CITY OF VANCOUVER
COMMUNITY SERVICES GROUP

DEVELOPMENT PERMIT STAFF COMMITTEE REPORT
MAY 21, 2014

510 SEYMOUR STREET (COMPLETE APPLICATION)
DE417745 - ZONE DD

East
Elevation

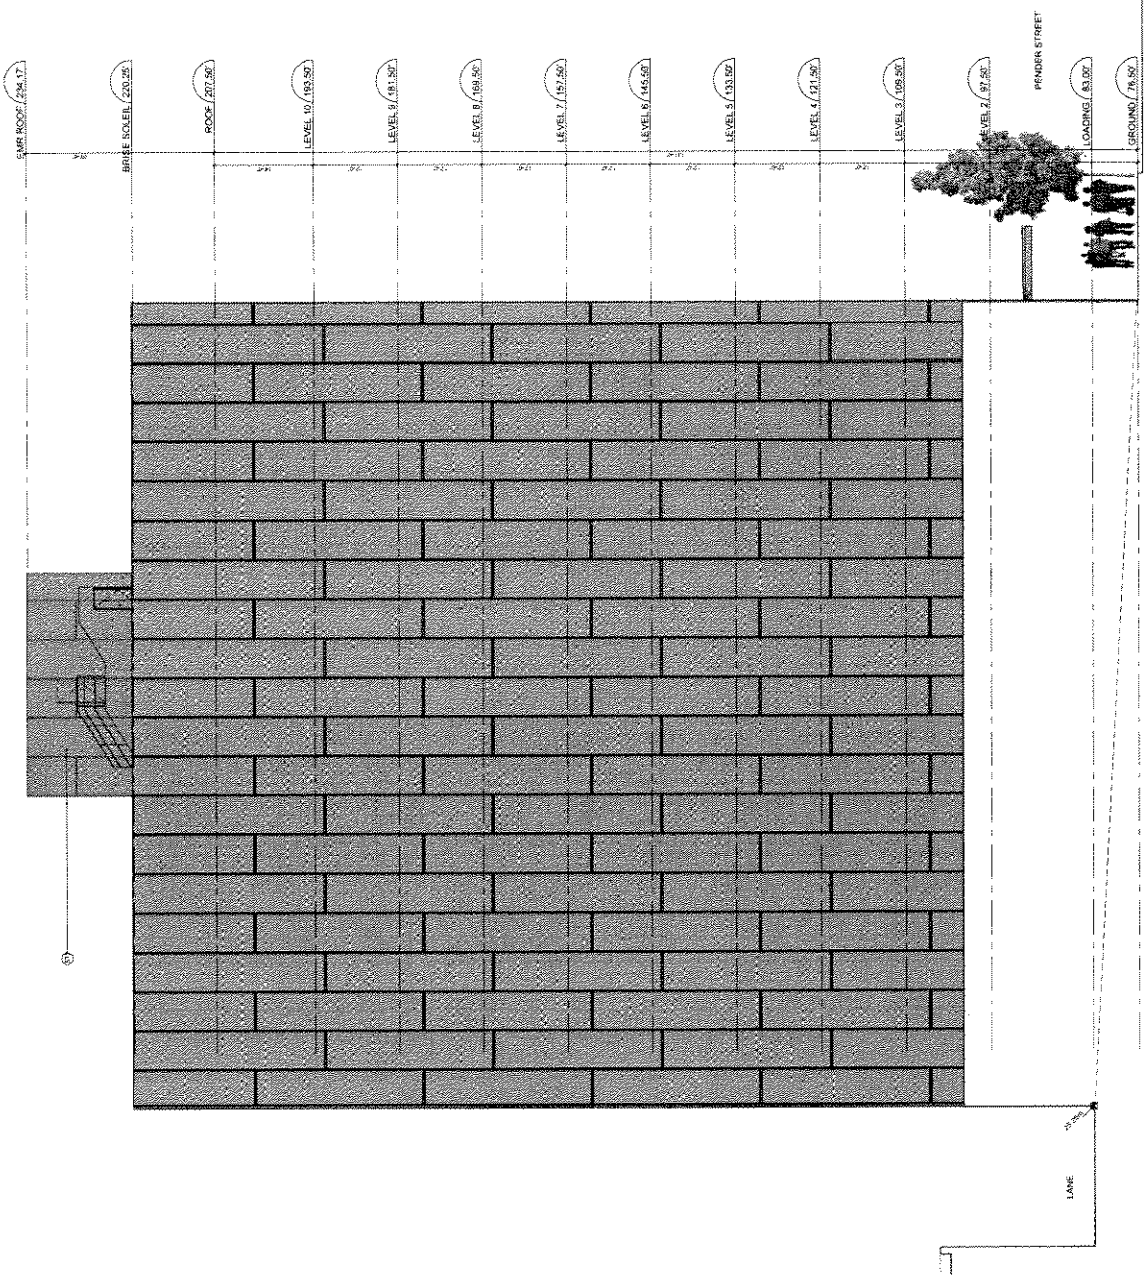
1.1 design development to the east elevation;

Note to Applicant: The east elevation is significantly higher than its neighbour and may be visible for some time. Increase the visual interest of this elevation through increased relief. This can be achieved by following the "basket weave" or "tilted planes" pattern on the other elevations, or through other techniques. Provide a detail dimensioning the proposed reveals.
